<b>DATE:</b>	April 2, 2026
<b>AGENDA ITEM:</b>	Discussion and Consideration Change Order #2 – Tricon Construction – Tiffin Water Treatment Facility Upgrade Project
<b>ACTION:</b>	Motion

**CHANGE ORDER NO.: 2**

Owner:	City of Tiffin	Owner's Project No.:	
Engineer:	MSA Professional Services	Engineer's Project No.:	13603021
Contractor:	Tricon Construction Group	Contractor's Project No.:	25-012-IA
Project:	Tiffin WTF Upgrade		
Contract Name:	13603021 – Tiffin WTF Upgrade		
Date Issued:	April 1, 2026	Effective Date of Change Order:	April 7, 2026

Project: Tiffin Water Treatment Facility Upgrade  
Re: COR # 3R2

**PROPOSED SITE PLAN**

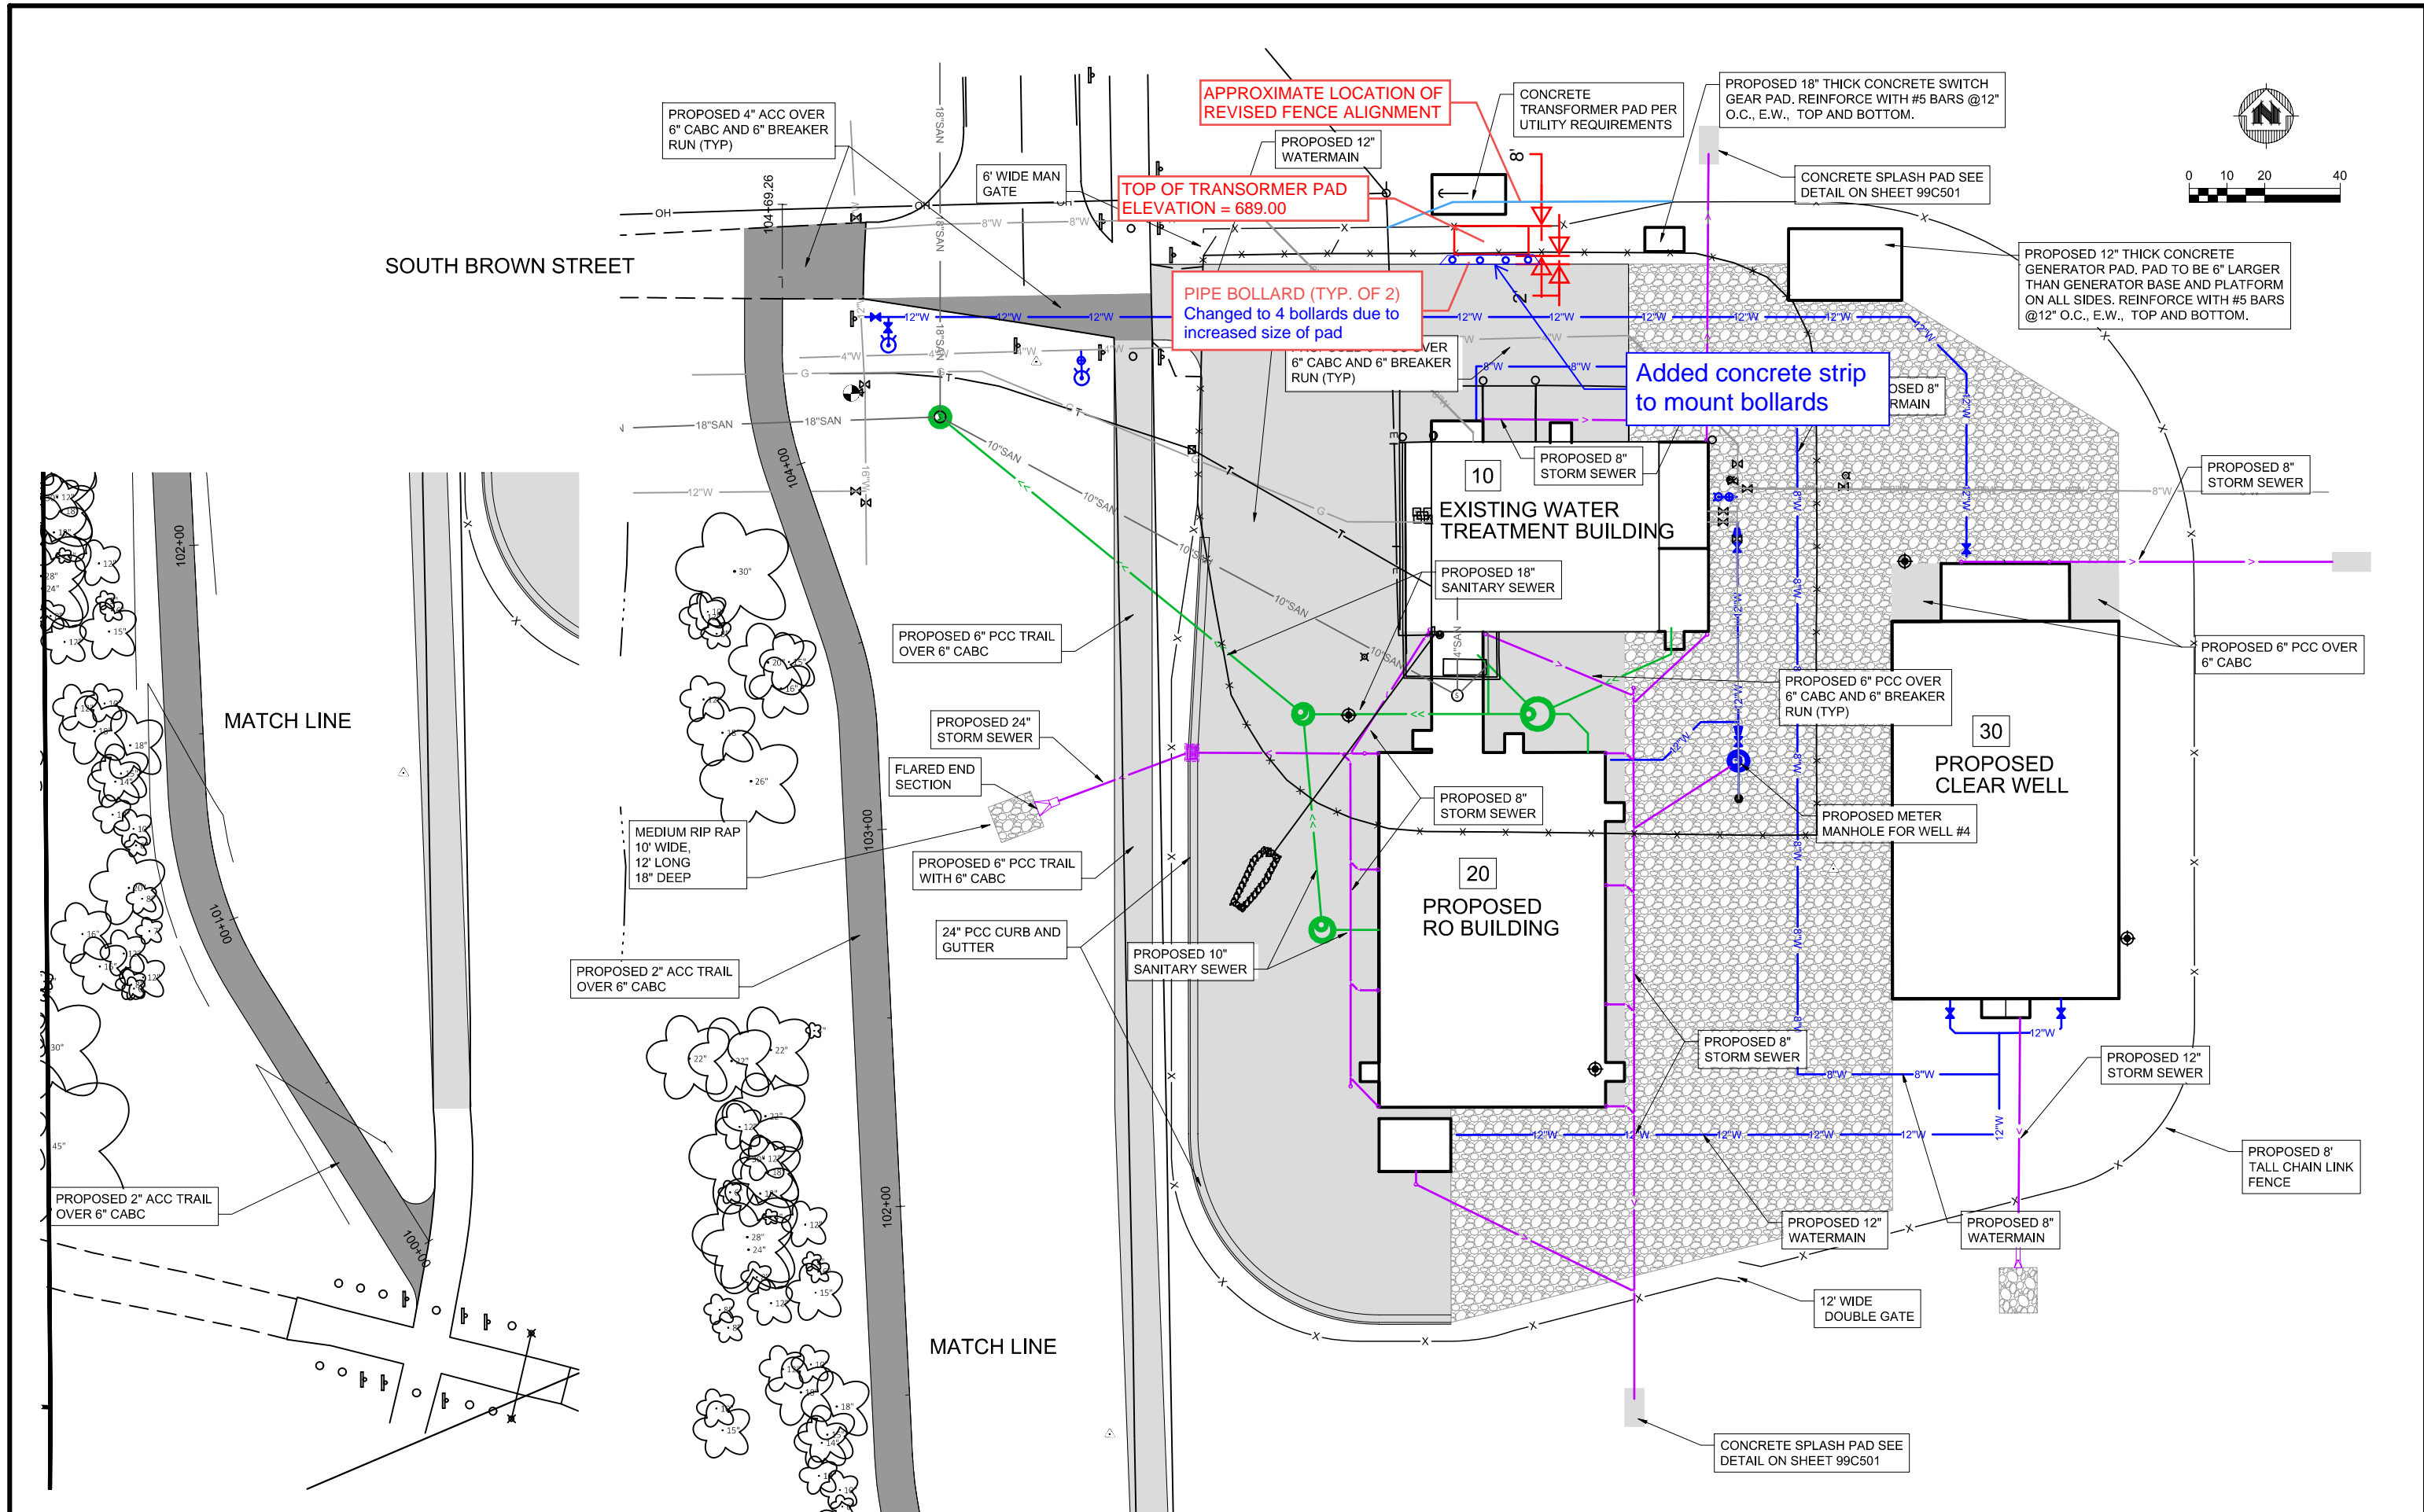
Transformer Pad Relocate - Added Bollards per RFI-014.

Alliant is requesting protective measures for the transformer now that it's inside the fencing and adjacent to the concrete paving, such as bollards or other.

**20-ARCHITECTURAL-PLAN-F.F.**  
 3/16" = 1'-0" (22" x 34")  
 3/32" = 1'-0" (11" x 17")

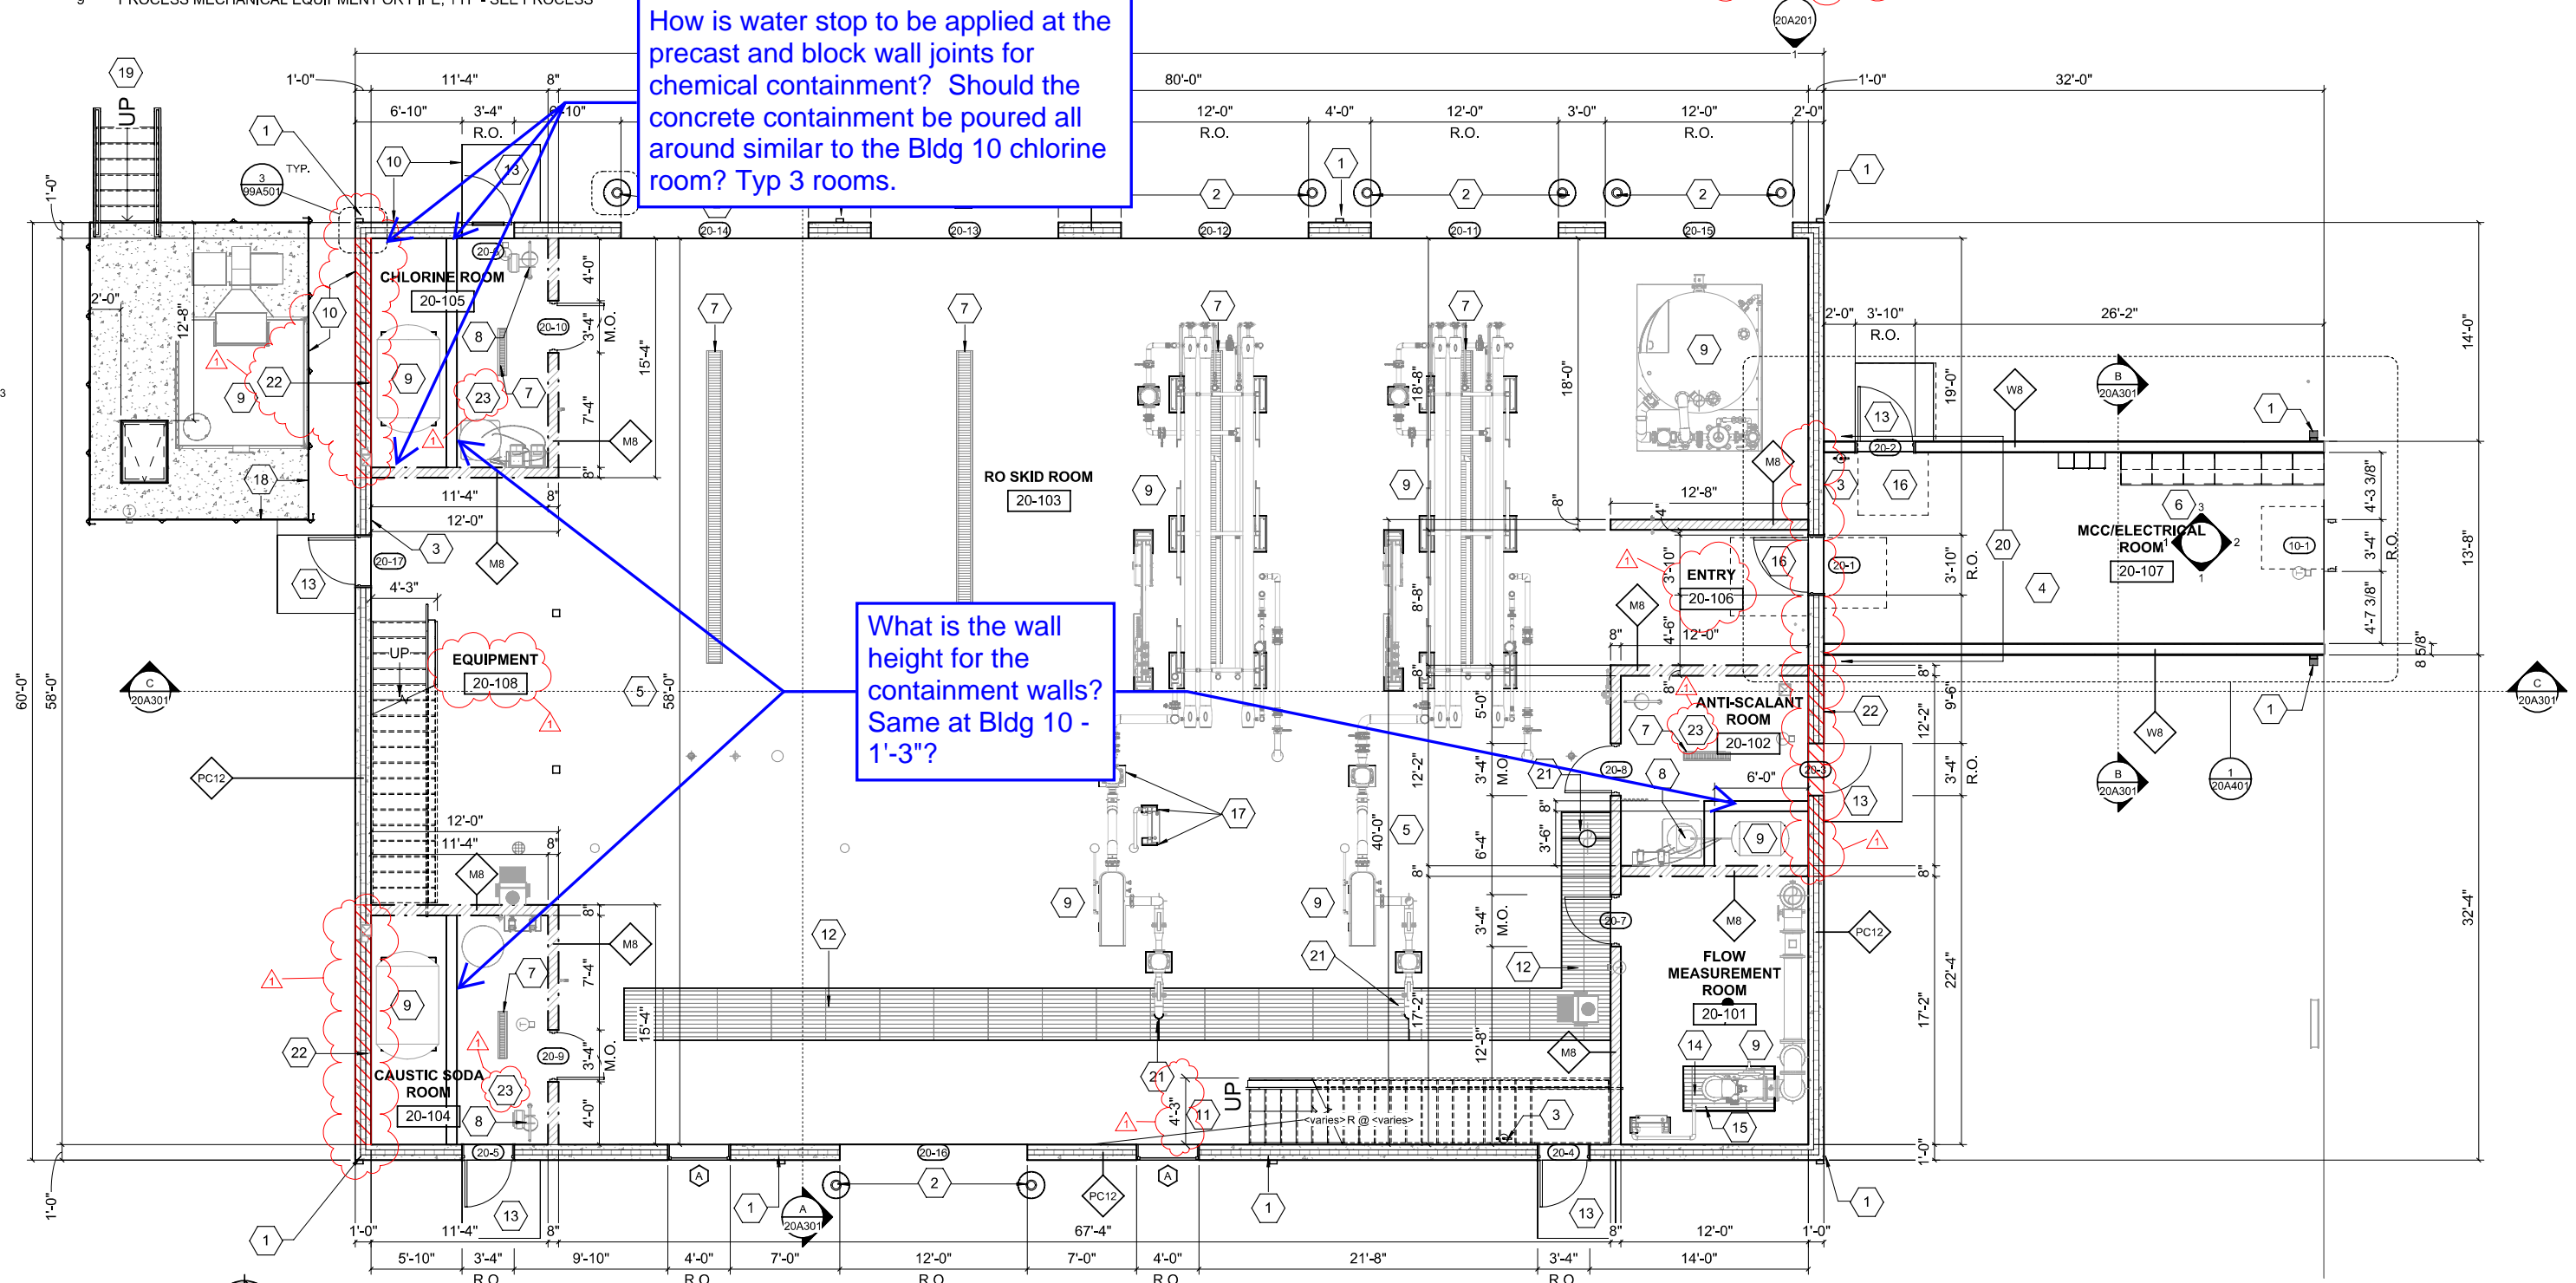
<b>Request:</b>	<b>Date Required:</b> 10/21/2025
<ol style="list-style-type: none"> <li>Please provide the wall height for the chemical containment walls in the RO Building.</li> <li>Please provide details as to how water stop should be applied for the chemical containment areas in the RO Building along the precast and block walls.</li> </ol>	
<b>Requested by:</b> Betty Keuter Tricon General Construction

How is water stop to be applied at the precast and block wall joints for chemical containment? Should the concrete containment be poured all around similar to the Bldg 10 chlorine room? Typ 3 rooms.

What is the wall height for the containment walls? Same at Bldg 10 - 1'-3"?

<b>Response:</b>
<p>1. By code there needs to be 110% of stored volume for containment. Wall heights we had were as follows:          Caustic Soda Room (20-104)= 18" (need 550 gallons of storage)          Chlorine Room (20-105) = 18" (need 550 gallons of storage)          Anti-Scalant Room (20-102) = 15" (need 83 gallons of storage)          The wall heights and dimensions can be adjusted as necessary for precast changes, etc. as long as the required storage volumes are satisfied.</p> <p>2. It would probably make sense to pour a 6" tall concrete curb to ensure there is not an leakage of chemical at the precast wall and CMU wall interfaces. 4" pvc waterstop would be installed in the floor slab at the concrete wall/curb interfaces. Hydrophylic waterstop shall be installed at the vertical interfaces between the precast/CMU walls and the concrete walls. See snip below on next page for reference.</p>

**10-STRUCTURAL-FRAMING PLAN**  
 1/4" = 1'-0" (22" x 34")  
 1/8" = 1'-0" (11" x 17")

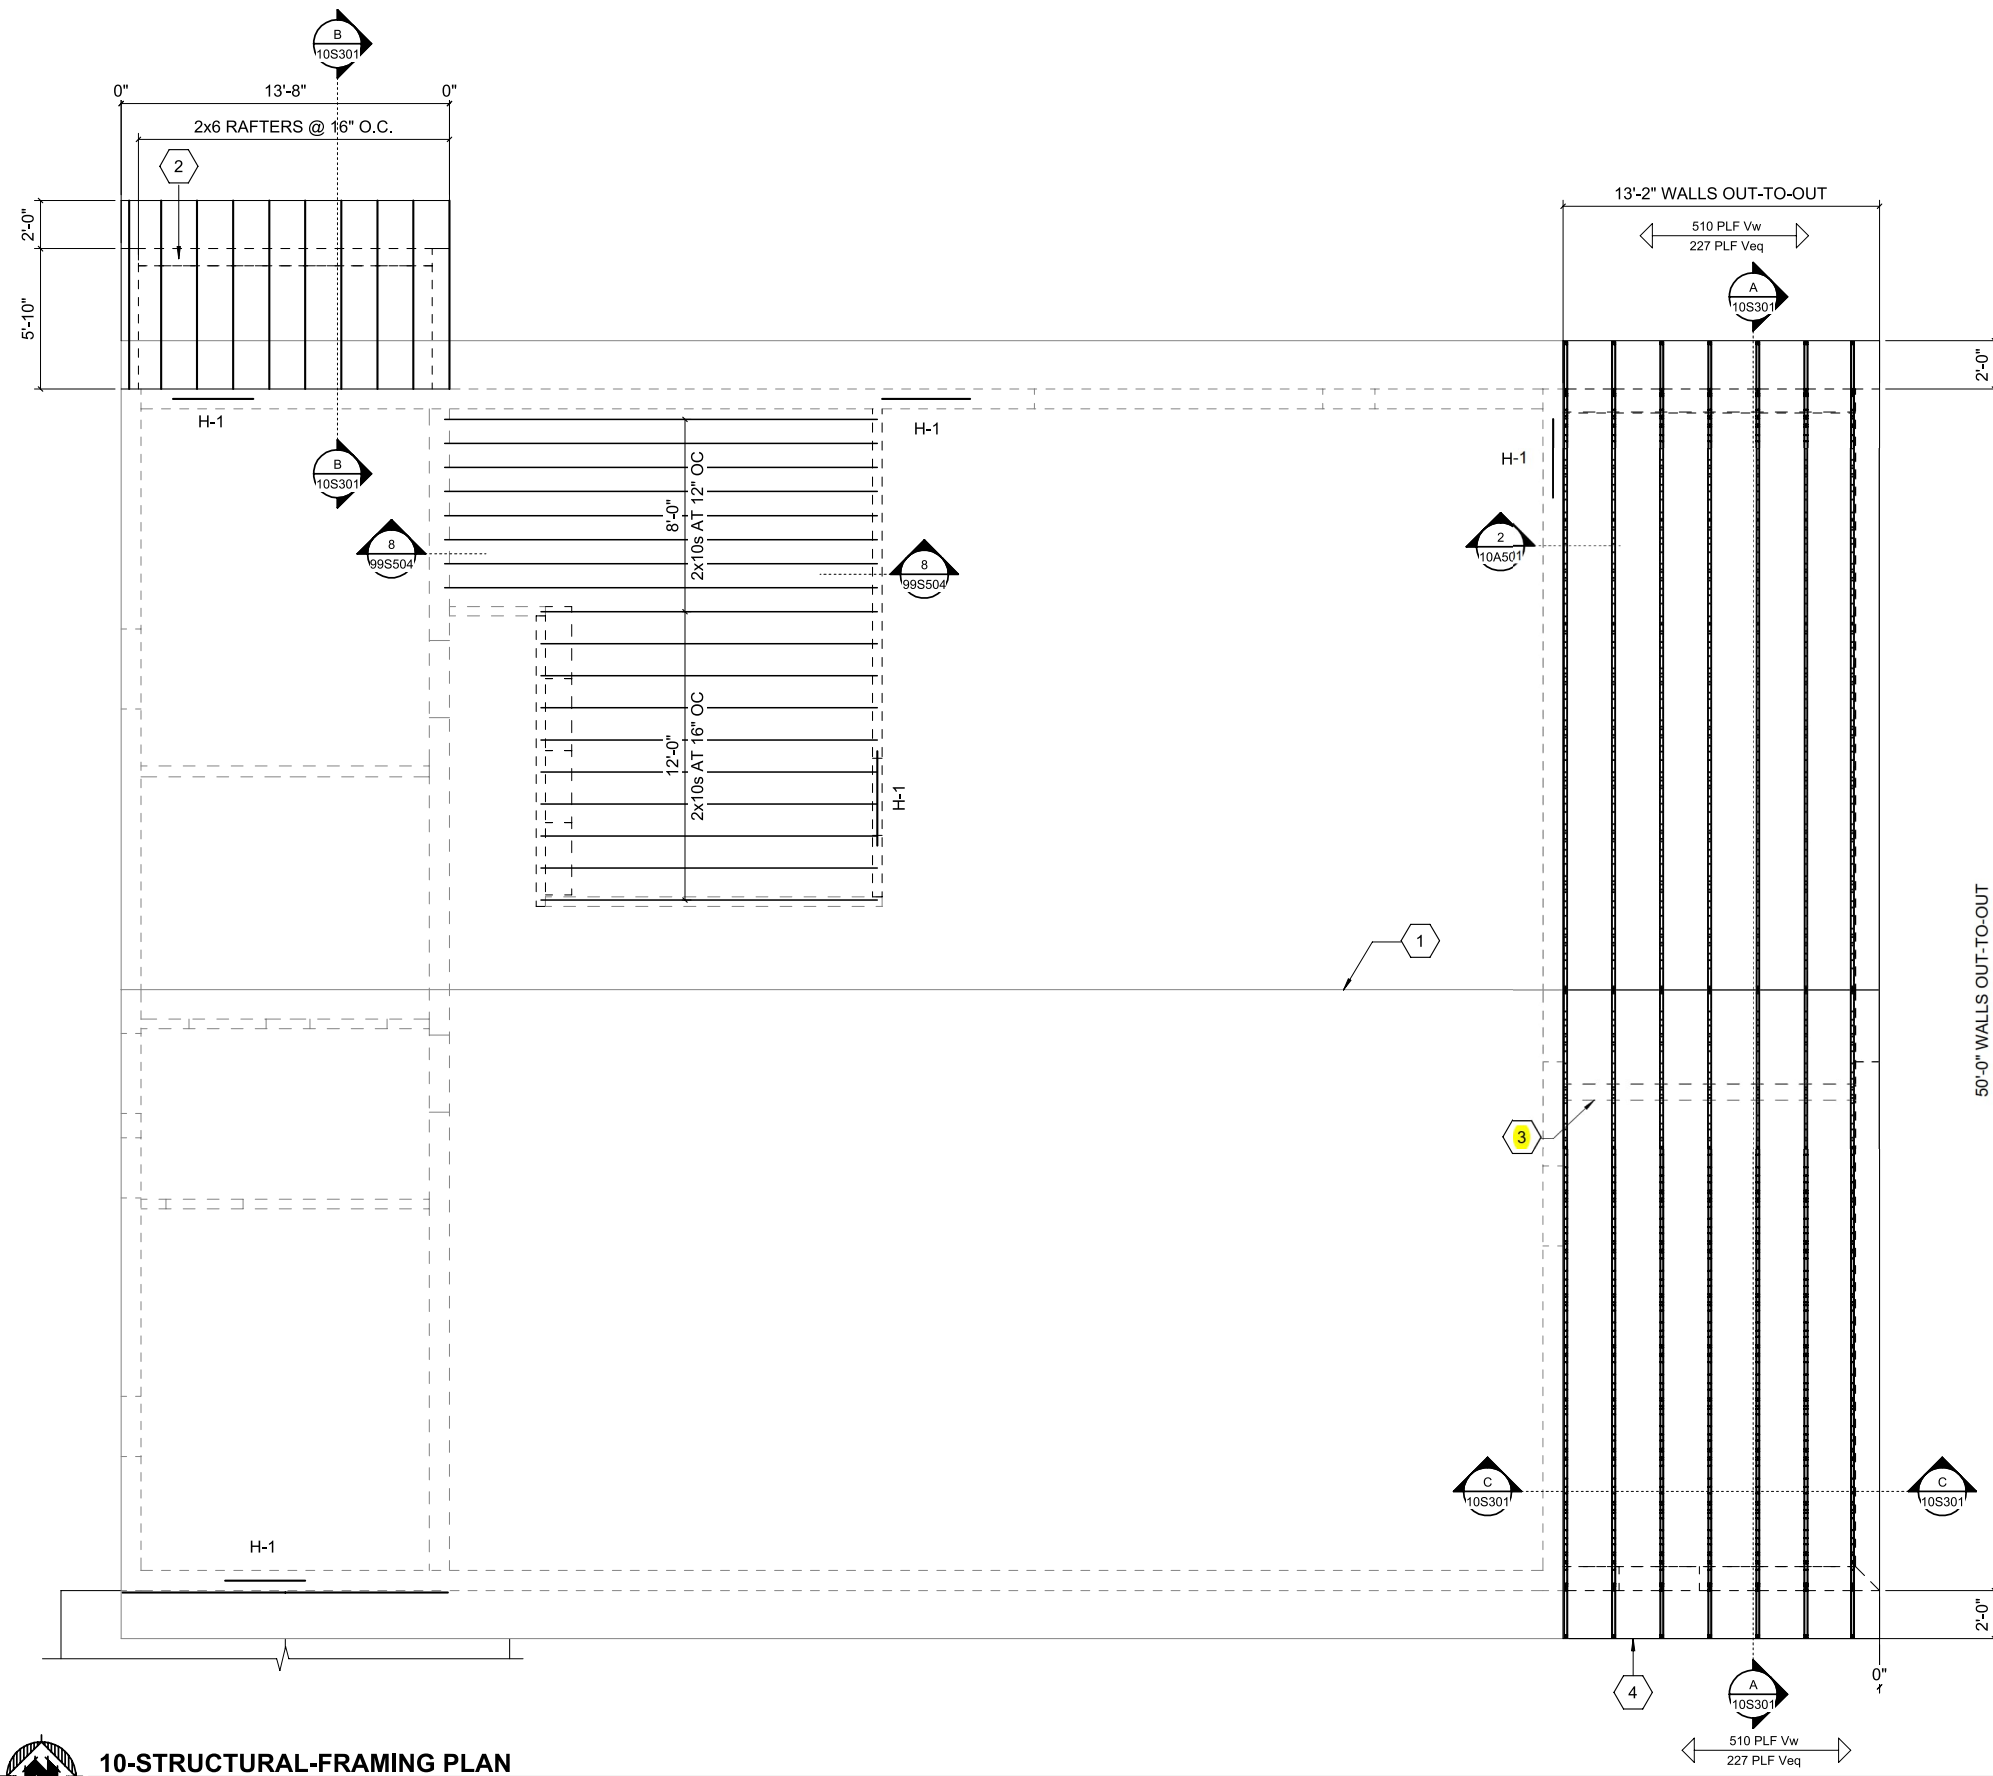
Building 10 Load Bearing Wall Changes per attached.
